BEFORE THE MERIDIAN CITY COUNCIL

IN THE MATTER OF THE REQUEST FOR FINAL PLAT CONSISTING OF 43 BUILDING LOTS [41 SINGLE-FAMILY, ONE (1) MULTI-FAMILY AND ONE (1) COMMERCIAL] AND SEVEN (7) COMMON LOTS ON 8.8 ACRES OF LAND IN THE R-15 AND C-C ZONING DISTRICT FOR LENNON POINTE SUBDIVISION.	)	**CASE NO. FP-2026-0014**
BY: RODNEY EVANS + PARTNERS, LLC APPLICANT	)	**ORDER OF CONDITIONAL APPROVAL OF FINAL PLAT**

STAFF REPORT

SUBJECT: Lennon Pointe Subdivision
FP-2026-0014

B. Final Plat (dated: 1/26/26)

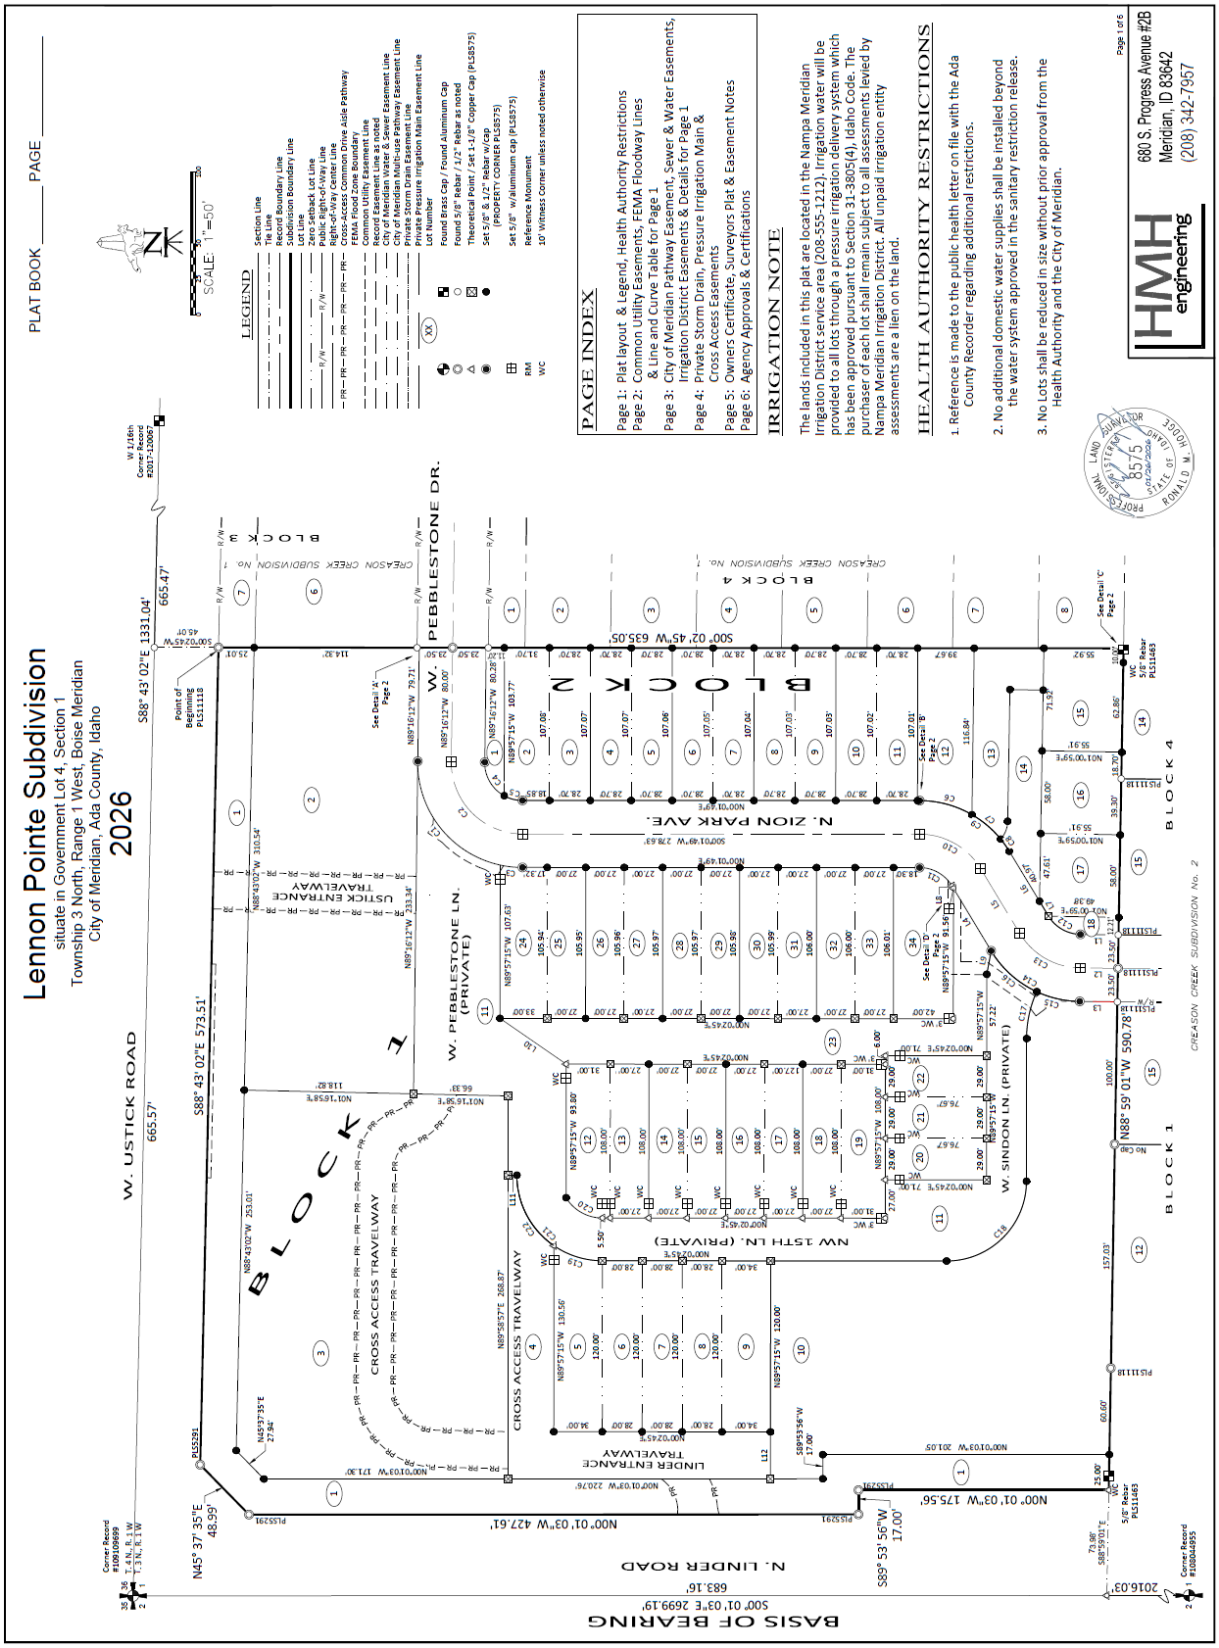
c. Modify Note #4: "Direct lot access to W. Ustick Road and N. Linder Road is prohibited except for those access points approved by the Ada County Highway District and <u>City of Meridian</u> as shown on the approved site plan."

i. Note #9: Delete as there is no note.

A copy of the revised plat shall be submitted with the Final Plat Mylar Signature application.
